U.S. Patent Application Serial No. **10/533,286**
Response filed March 21, 2007
Reply to OA dated December 21, 2006

REMARKS

Fig. 8

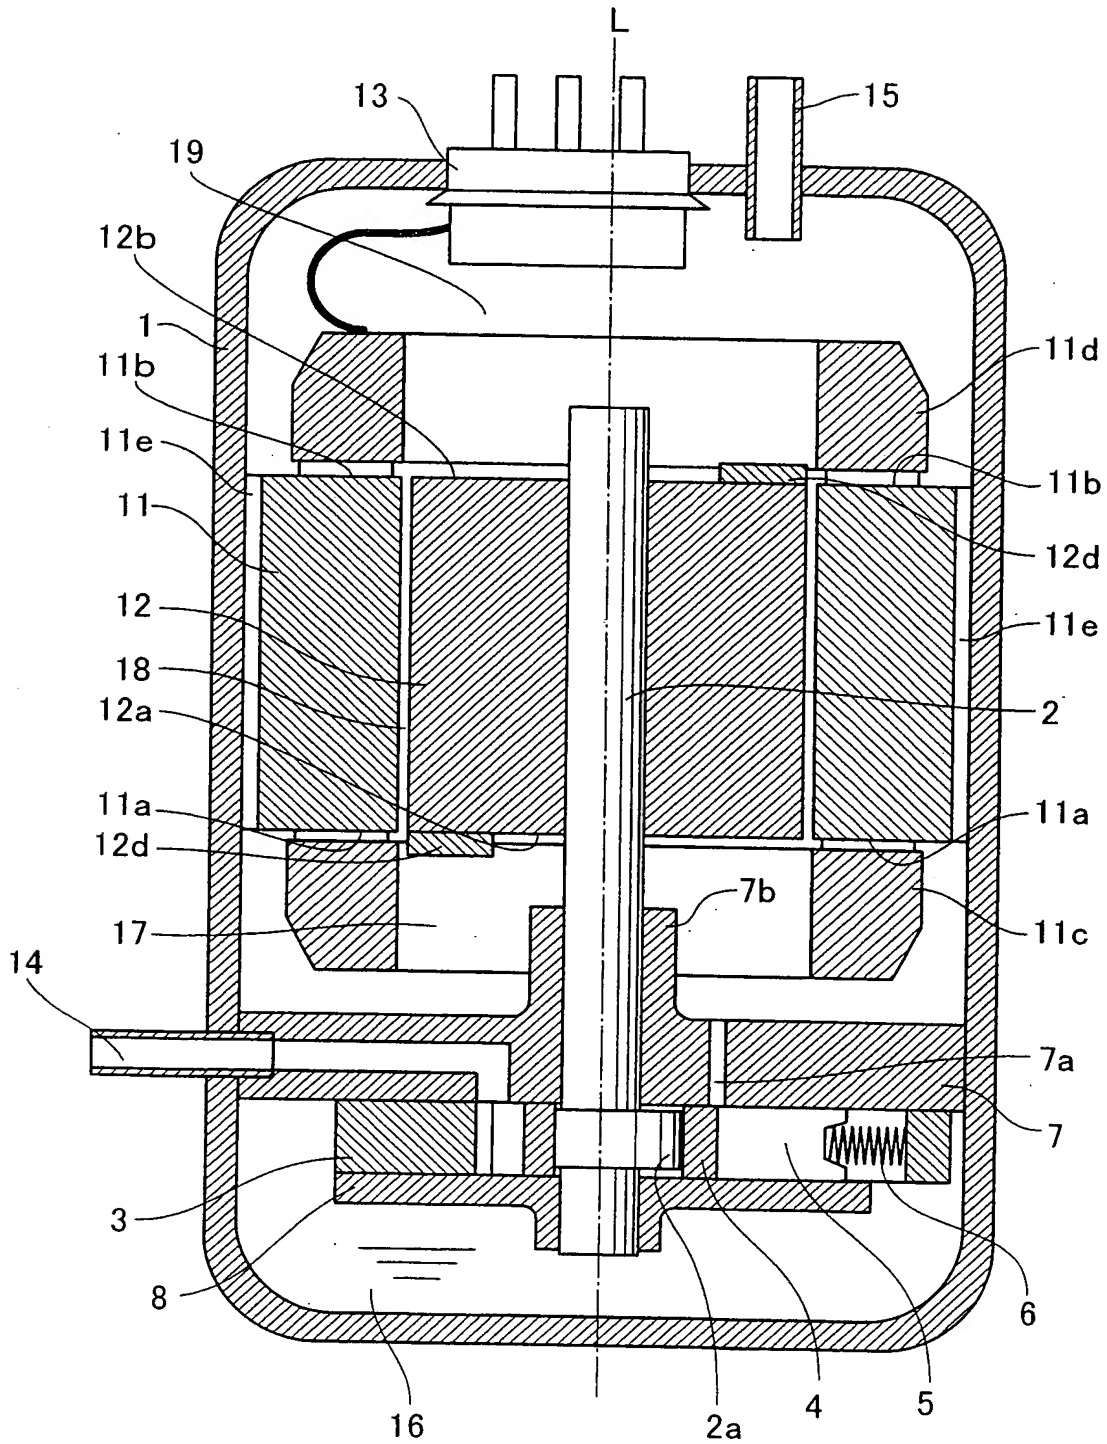
Figures 8-10 should be designated by a legend such as --Prior Art-- because only that which is old is illustrated. (Office Action, p. 2)

FIGS. 8-10 have been amended with the legend --Prior Art-- as suggested by the Examiner. It is respectfully asserted that no new matter has been added.

PRIOR ART
